SOUTHERN PARKLANDS M12 CORRIDOR REVIEW

Submission to RMS

For: Western Sydney Parklands Trust

Date: 18.11.2019

Figure 07
Overlay of M12 on to Northern Precinct

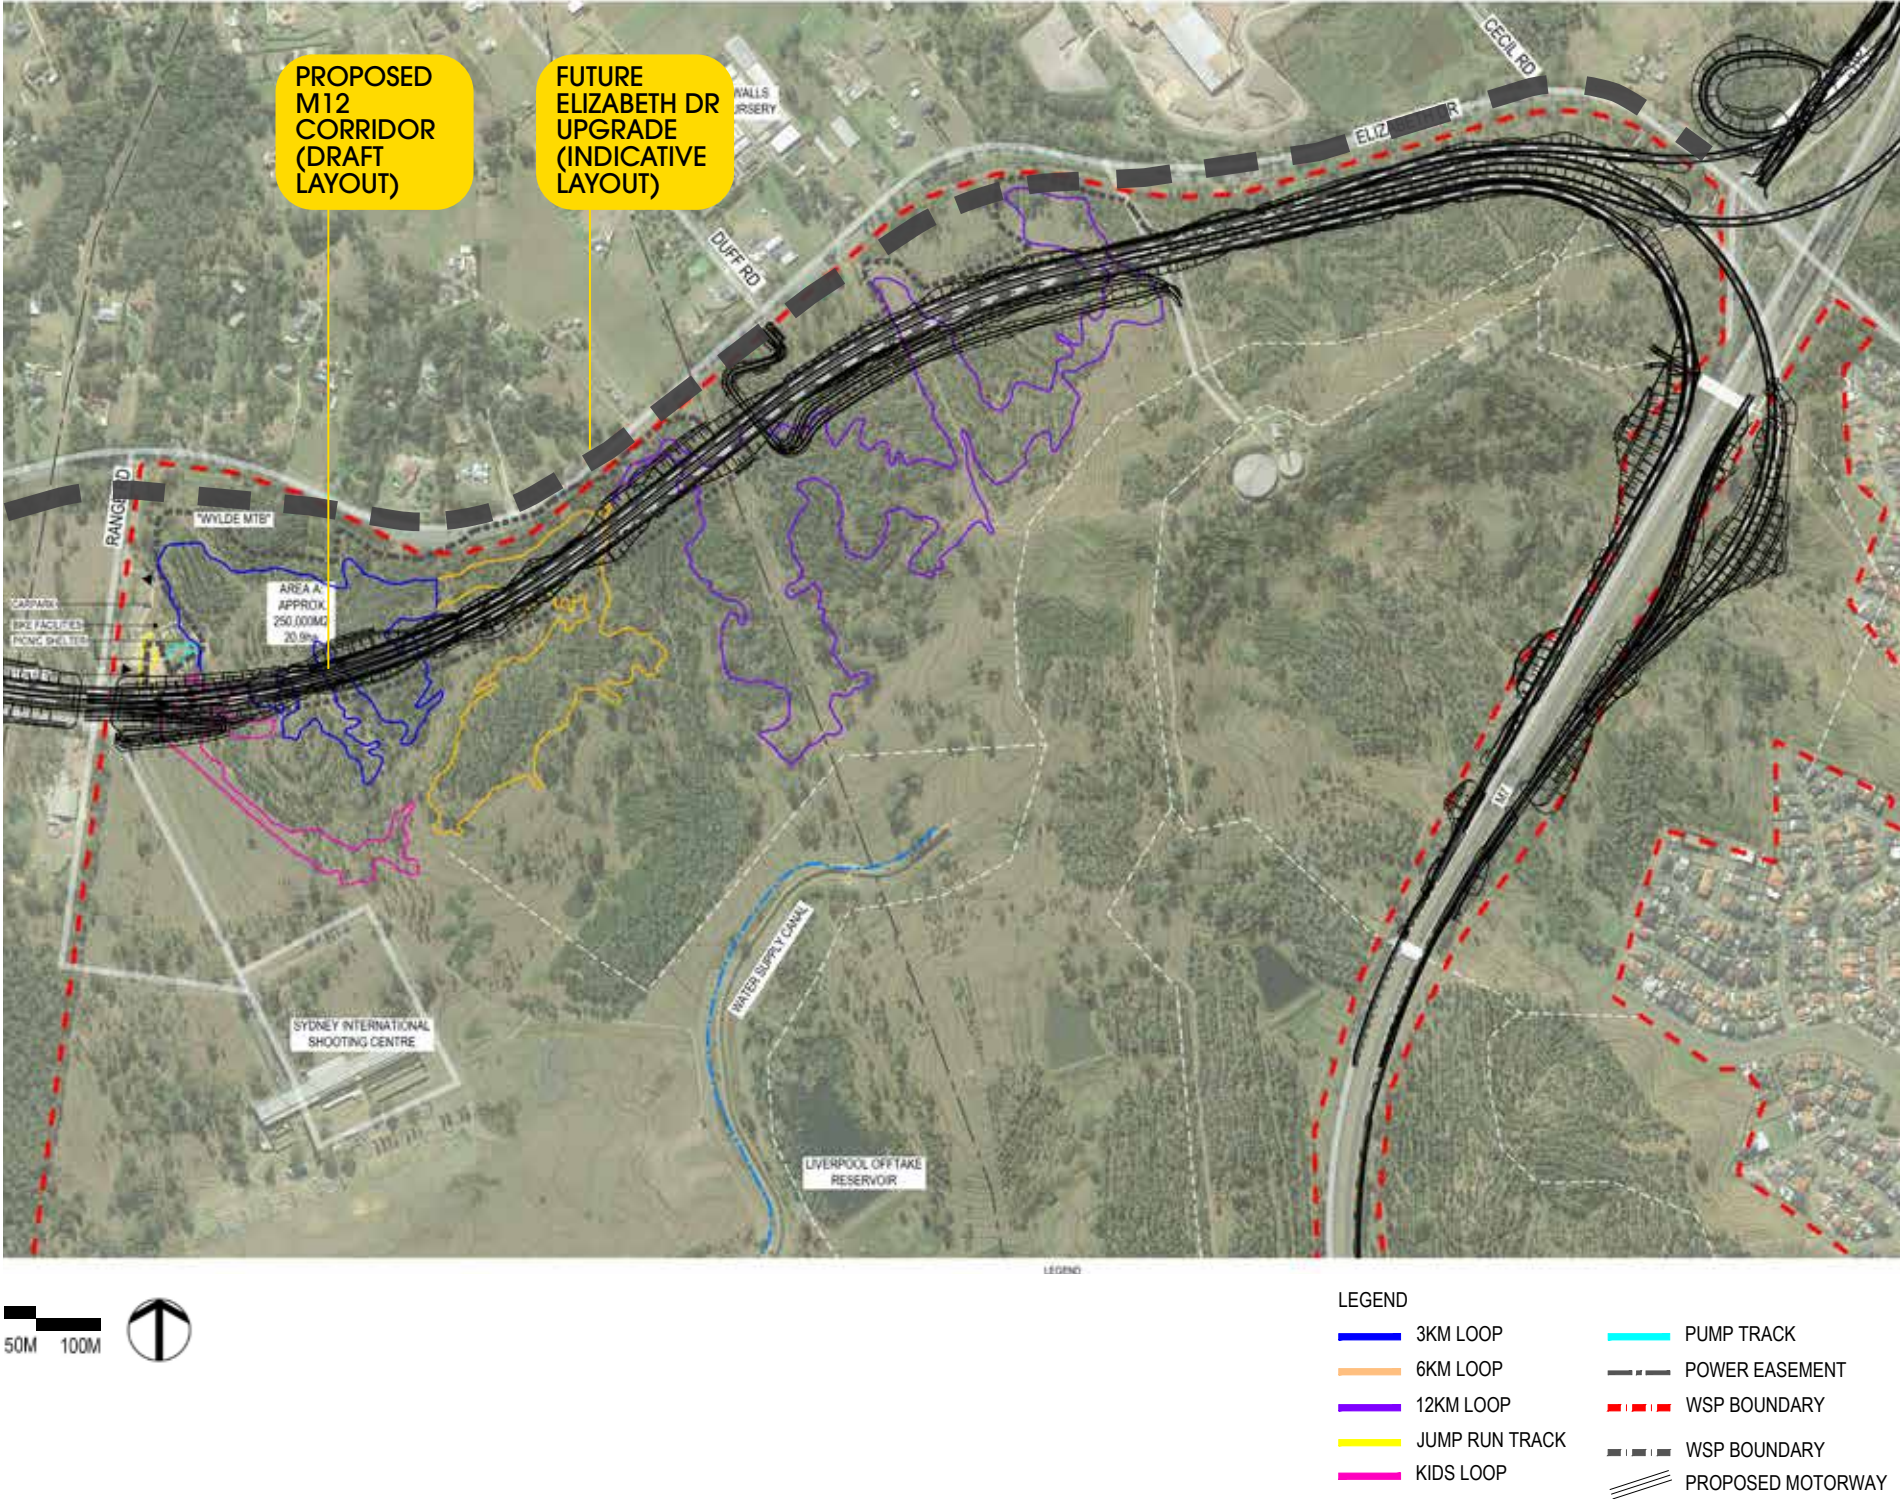
- The final design height of the M12 roadway impacts the extent of cut either side of the roadway.
- At the crossing of Range Rd, the roadway is an elevated bridge, approx 8m above road level.
- Opportunities for crossing the M12 are influenced by height relationship between M12 and Elizabeth Drive and Parklands levels.

- The proposed M12 alignment overlaps the Wylde MTB Trail, and will effectively remove the area of existing trail which runs along the northern edge of the Southern Parklands. Refer following pages for more detailed review.
- There is potential to reinstate MTB Trails in the Range Road proximity, between the M12 embankment and Elizabeth Drive, which would be reinstated following the M12 construction.

- The planned M12 roadway alignment overlaps the current entry, parking, pump track / jump run areas, which effectively requires the removal of the MTB entry precinct to construct the M12 Bridge.

- The impacts on construction, and the requirements for storage, management and safety curtilages will impact the operation of the MTB facility in the construction period.

Figure 08
Areas Impacted by M12

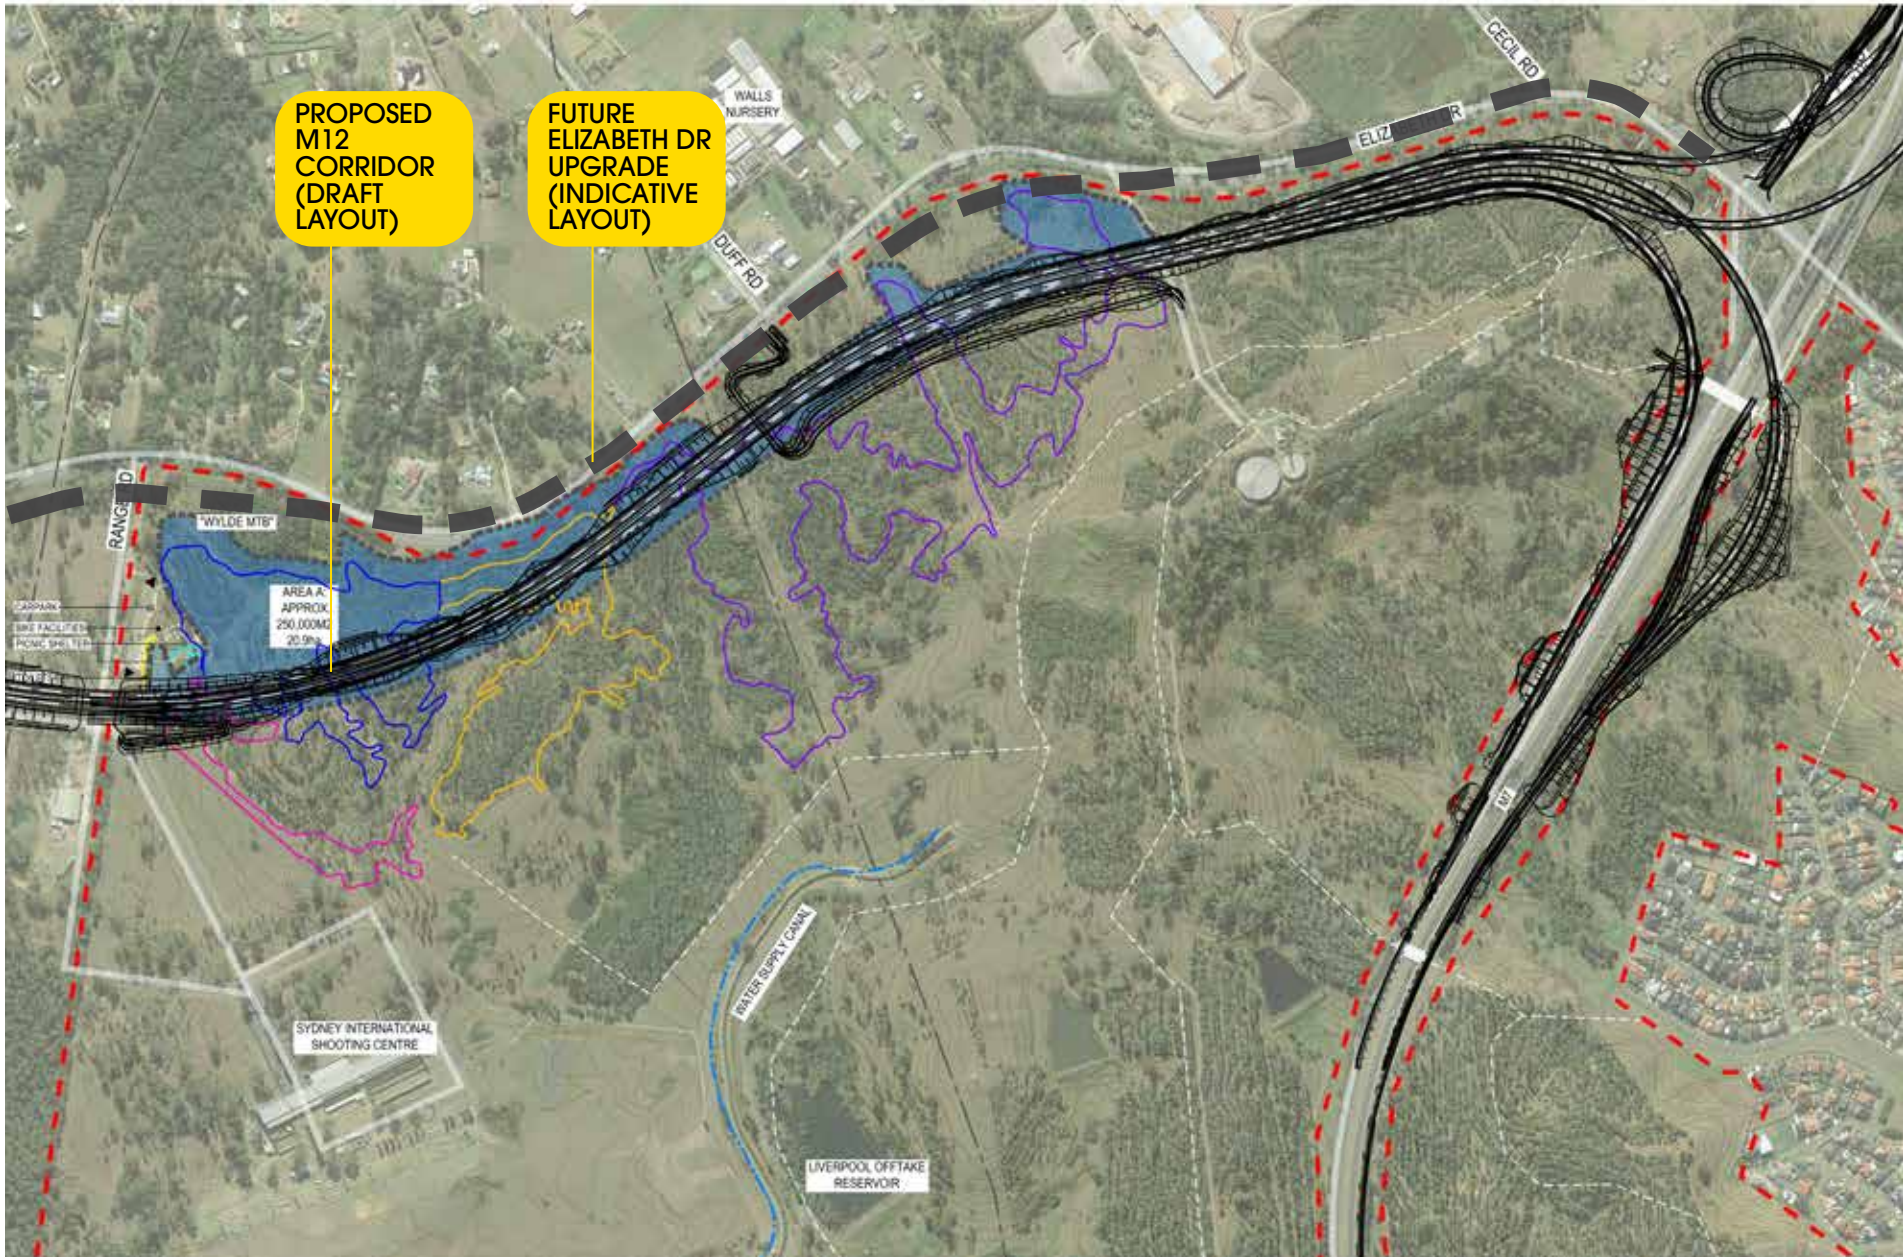
It is planned that Elizabeth Drive will be realigned to provide a more even and consistent road geometry. The likely impact of this will be that Elizabeth Drive will be closer the Parklands - and the M12 - in some areas. An estimated road geometry for Elizabeth Drive is been shown on Figure 08.

The direct impact on the loss of usable areas for the MTB trails is shown on Figure 08. The areas of impact include:

- Areas of the MTB Loop trails.
- Entry precinct, including car parking, toilets, signage, pump tracks and shelters.

To avoid prolonged impacts to the operation of Wylde MTB, it is planned to relocate the entry precinct and tracks to a new location prior to the commencement of the construction of the M12 Motorway.

Figure 10
Duff Road Entry Parklands Connection

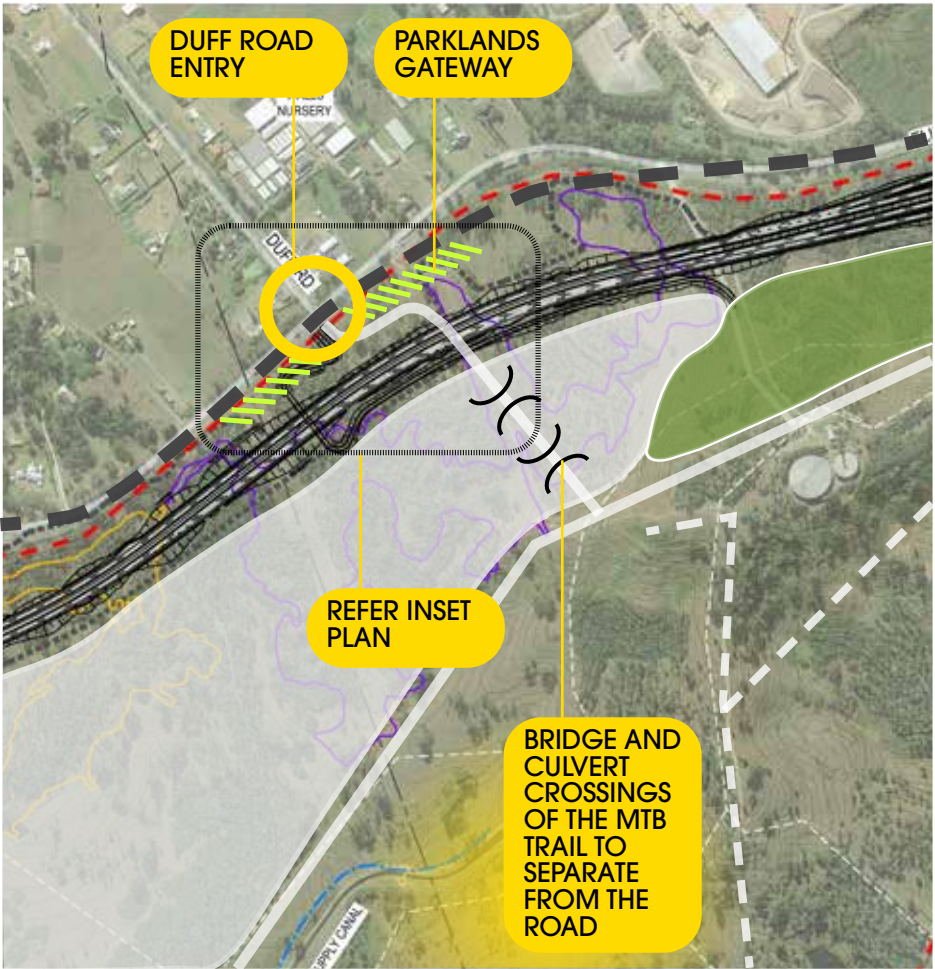
As a major park entry, the built outcome of the road entry, embankment and bridge needs to reflect the Parklands design character and quality. The bridge form, alignment and road geometry is to be developed with the WSPT to ensure an integrated and cohesive outcome will be achieved.

The performance criteria of the bridge is to cater for two traffic lanes in each direction, entering and leaving the Parklands. The intersection with Elizabeth Drive is it cater for a signalised intersection with two lanes each direction, to accommodate visitation during events and peak periods.

The Duff Road entry connects to the Parklands in the location of the proposed MTB trails. Due to operational requirements, the MTB tracks cannot cross the entry road. The MTB trail will need to be separated from the road with bridges or underpasses.

- Provides major connection to the future Parklands Hub.
- Provide safe ‘all movement access’ signalised intersection at Elizabeth Drive.
- Bridge over the M12 provides elevated views over the Parklands
- Bridge over the M12 to be a high quality design outcome and reflects design language of the Parklands.
- Bridge over the M12 to support future access capacity requirements to the Parklands.
- Parklands gateway treatment along the Elizabeth Drive roadway, integrated with bridge abutment and embankment treatment.
- Include pedestrian / shared cycleway across bridge.
- Opportunity to identify the Parklands through the bridge design when traveling along the M12.
- The road within the Parklands will connect through hillside, creating a memorable ‘landscape’ experience.
- Separation is required between the MTB trails and road.

Figure 12
Range Road Entry Parklands Connection

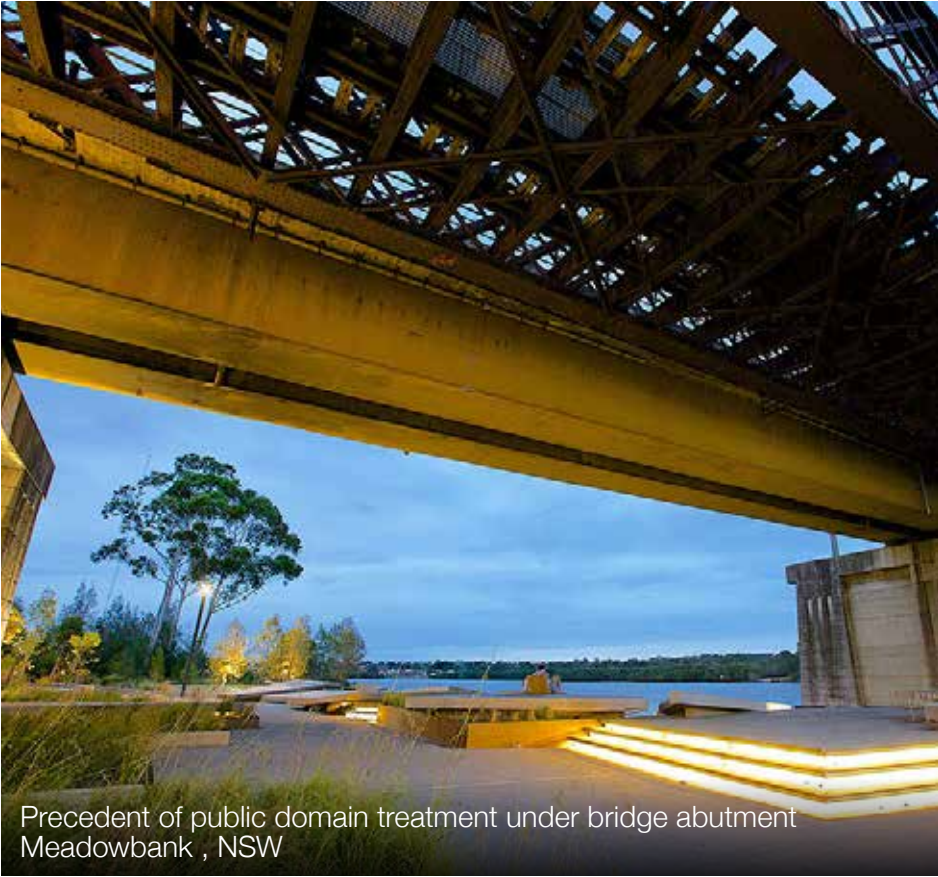
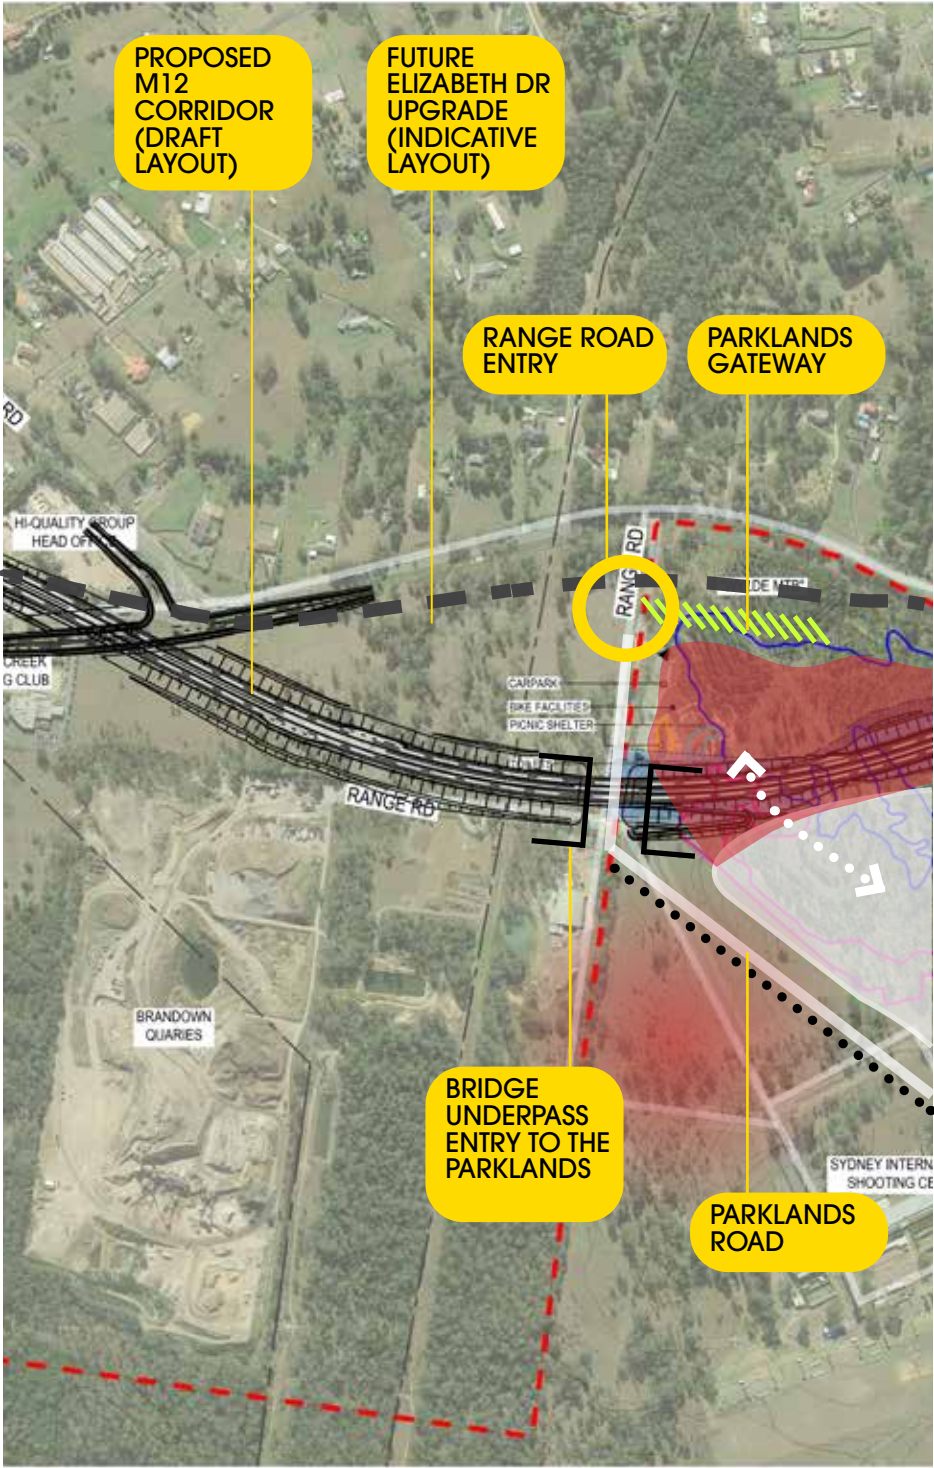
The reconfigured Range Road off Elizabeth Drive will be another key entry point for visitors to the Parklands. The Range Road entry is under the elevated M12. The M12 bridge is approx 8m higher than Range Road at the crossing point.

As a key park entry, the experience of the bridge underpass needs to reflect the Parklands character and quality. The bridge underpass needs to establish a quality public domain outcome for visitors entering the Parklands in vehicles as well for pedestrian / cycle amenity.

- Provide safe 'all movement access' signalised intersection at Range Road and Elizabeth Drive.
- Provides a clear gateway to the future Parklands Hub.
- Connects well to the SISC, Wylde MTB Trail and future Parklands Hub.
- Underpass under the M12 bridge provides a quality entry experience.
- Provides provision for the cycleway shared path through the Parklands.
- Cycleway connects to the M12.
